DEVELOPMENT REVIEW BOARD APPLICATION

**RE: FINAL SIGN OFF OF EPC SITE PLAN
(PROPOSED 30 DWELLING DEVELOPMENT)
TRACTS 27A-1 AND 27A-2 OF TAYLOR RANCH, REDIVISION
OF TRACT 27A INTO TRACTS 27-A-1 AND 27-A-2 OF THE
PLAT OF TRACTS 27-A, S-1, S-2, AND S-3 TAYLOR RANCH,
SITUATED WITHIN SECTIONS 23, 25 AND 26 T11N R2E, BLOCK 0000,
LOCATED AT THE NORTHEASTERN CORNER OF THE
INTERSECTION OF MONTAÑO ROAD NW AND TAYLOR
RANCH ROAD NW (4701 MONTAÑO ROAD NW),
APPROXIMATELY 3.4 ACRES (E-11-Z AND E-12-Z)**

Project #2020-003461
SI-2020-00052—Site Plan-EPC, Major Amendment

DESIGNERS	SARANAM AT 4701 MONTANO RD NW	DESIGN BY	
DATE	7/28/2020	DATE	
CONSTRUCTION DETAILS		2019980.DWG	
SHEET #	C5

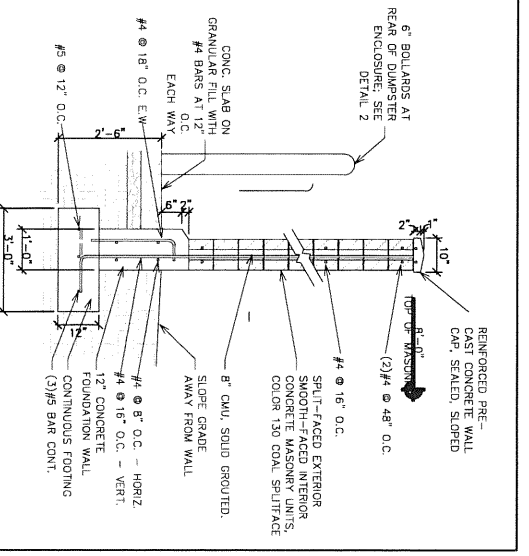
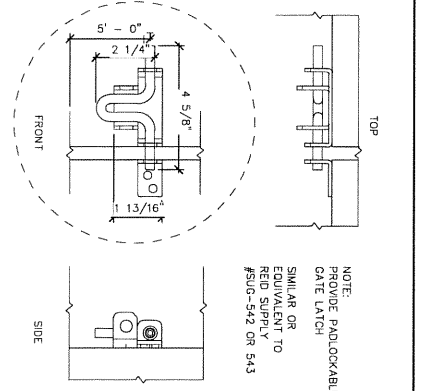
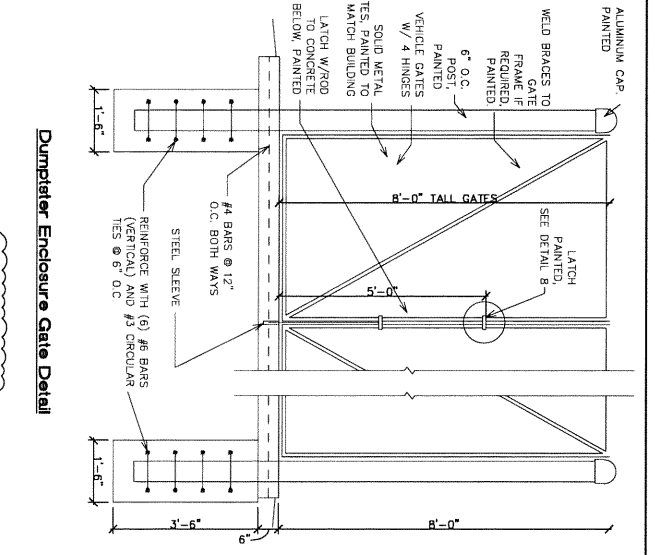
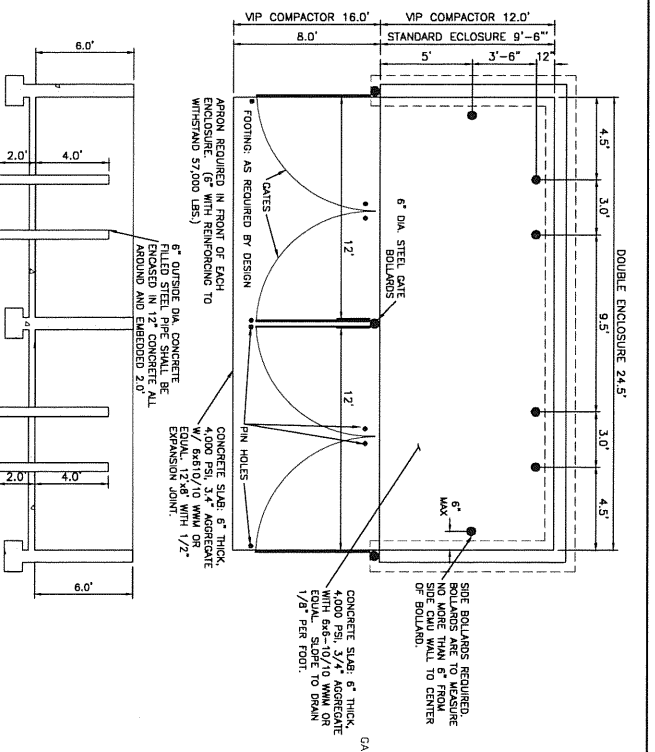
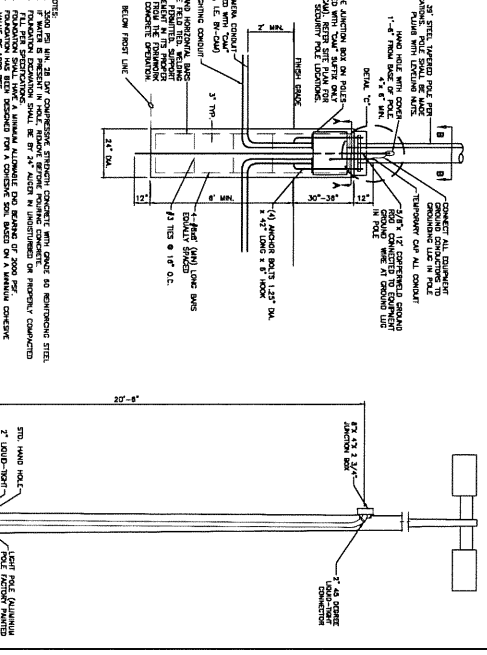
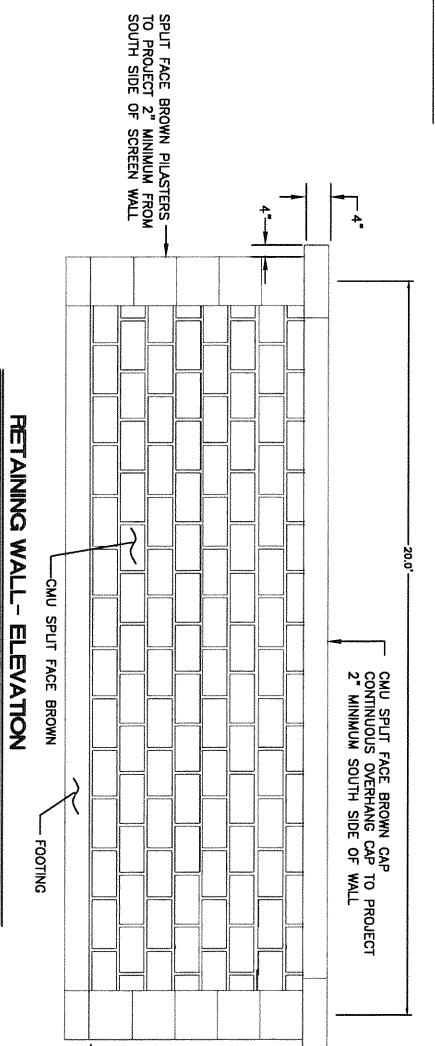
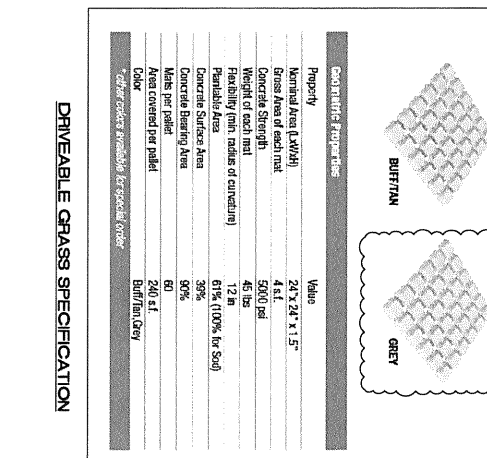
- A. The proposed, new retaining wall shall comply with the wall design requirements in IDO Section 14-16-5-7(E).
- B. A front-facing wall detail shall be provided.
- C. The refuse enclosure detail shall specify materials, colors, and finish.

- A. A light pole detail indicating height, color, and finish shall be provided [IDO Section 14-16- 5- 8-(D)(7)].
- B. Light pole locations shall be shown and a consistent symbol used.

- C. Fire Marshall approval of the site plan is required.
Received approval.
- D. Provide details for bollards at Montañó Road and landscape pavers. Coordinate with Fire Marshall.
Added to Detail Sheet C5.

Response: wall complies with IDO 14-16-5-7(E), front facing details added detail sheet C5, and refuse enclosure details for color added.

Response: Light pole detail with height, color and finish added to detail sheet C5 and the symbol used is consistent throughout.

Sheet Number: LP-01

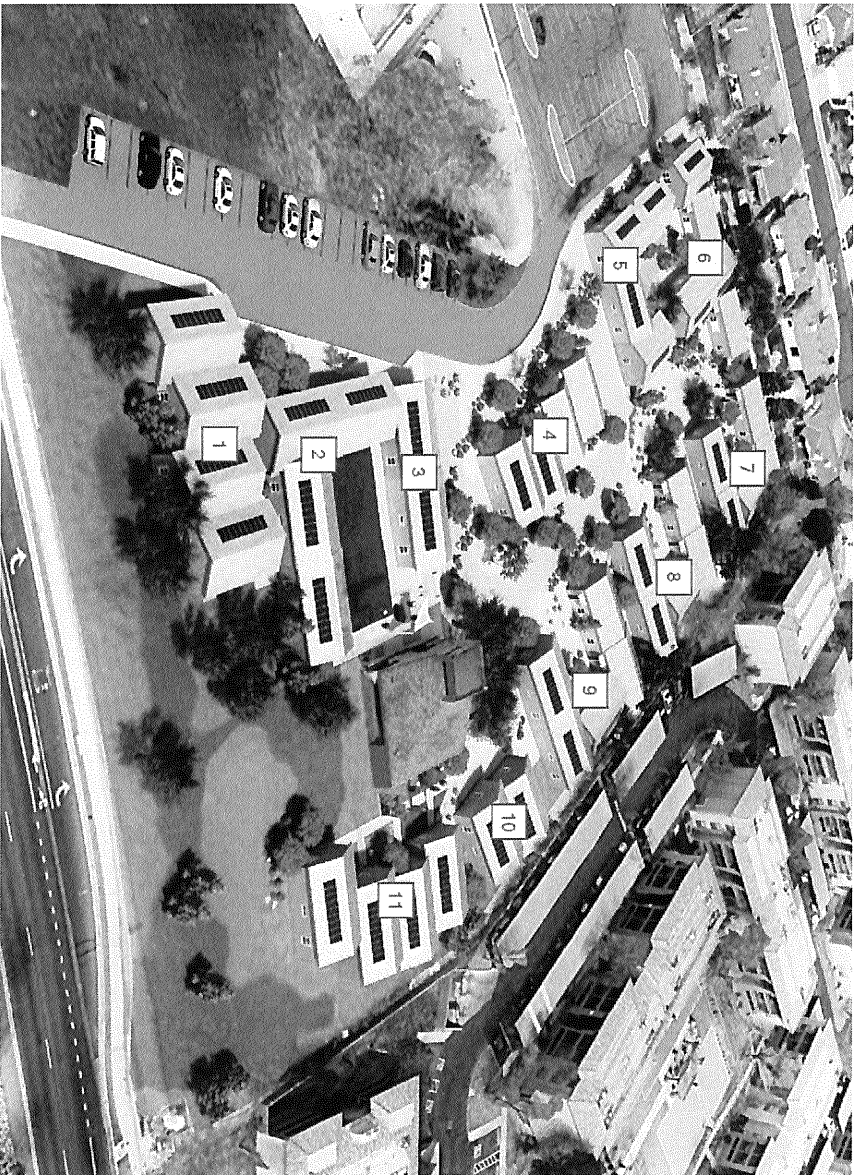
- A. Shade trees shall be provided along required pedestrian walkway [IDO Section 14-16-5-3(D)(3)(b)(2)(a)] along the project site's western boundary. An on-site pedestrian walkway that connects to the sidewalk is required pursuant to.
- B. At least 10% of the parking lot area shall be landscaped [IDO Section 14-16-5-3(F)(2)(a)].
- C. Parking lot trees shall be provided at the rate of 1 tree per 10 parking spaces. With 45 required spaces, 5 trees shall be provided. [IDO Section 5-6(F)(2)(c)(1)].
- D. Clarify and ensure that 1 tree per dwelling unit (30 trees total for the DUs) is provided pursuant to the Use Specific Standards for multi-family development [IDO Section 4-3-(B)(7)].

- A. Curb notches shall be labeled and match locations on the grading and drainage plan(s).
- B. A curb notch detail shall be provided.
- C. The northern landscape buffer width shall be labeled consistent with the width shown on Sheet C-1.
- D. Specify if the boundary along the project's western side is a wall or edging.

Response: Landscape comments A-D addressed on the revised landscape plans.

Response: Landscape detail comments A-D updated on revised plans

UNIT NO. 6 - TYPICAL

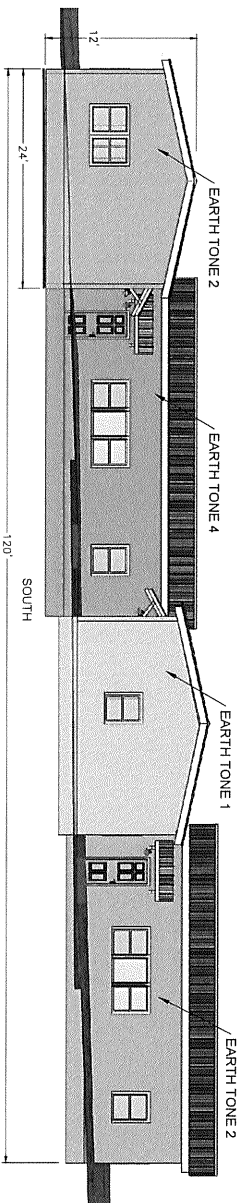
C. The word "typical" shall be added to the labels for Unit 6 and Unit 9.

Response: elevations for the accessory buildings 1, 2 and 3 added to the elevation sheets, and the materials and finishes of the buildings, roofing, framing, and trim, are specified. "Typical" added to the labels for Unit 6 and Unit 9.

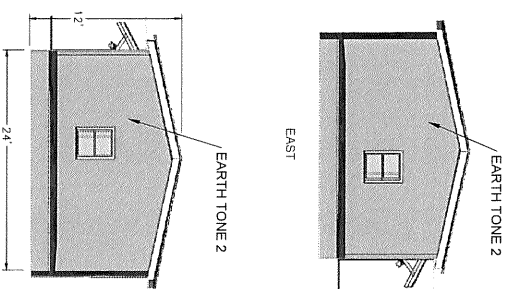
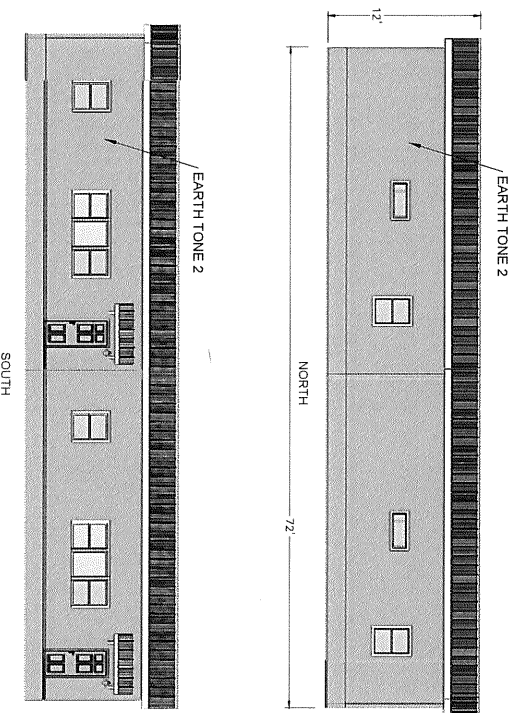
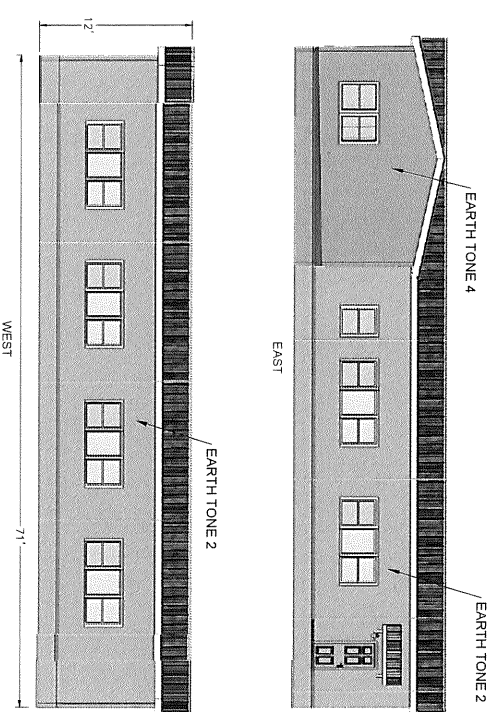
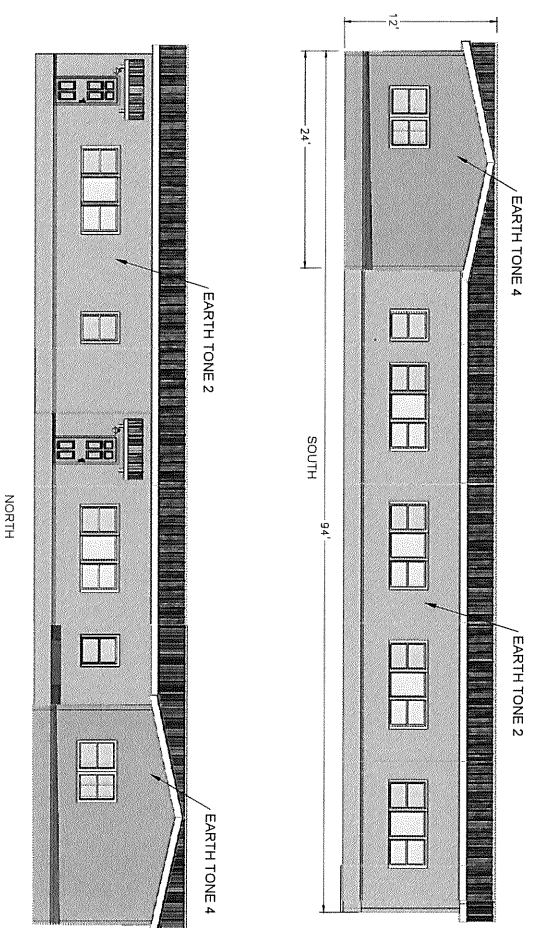
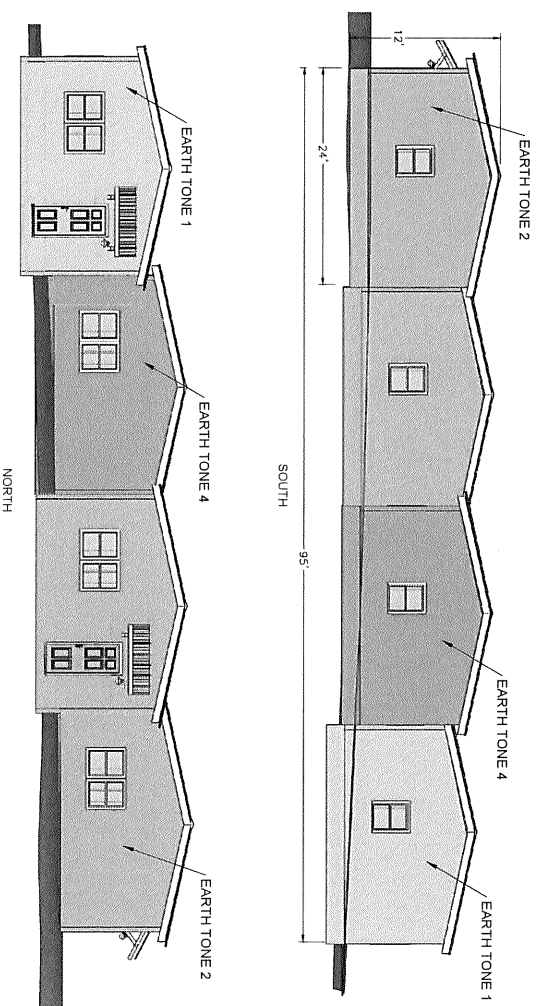
- A. Elevations for the accessory buildings (1, 2, and 3) shall be provided and provide necessary details such as dimensions, colors, and finishes.
- B. The materials and finishes of the buildings, roofing, framing, and trim, shall be specified.
- C. The word "typical" shall be added to the labels for Unit 6 and Unit 9.
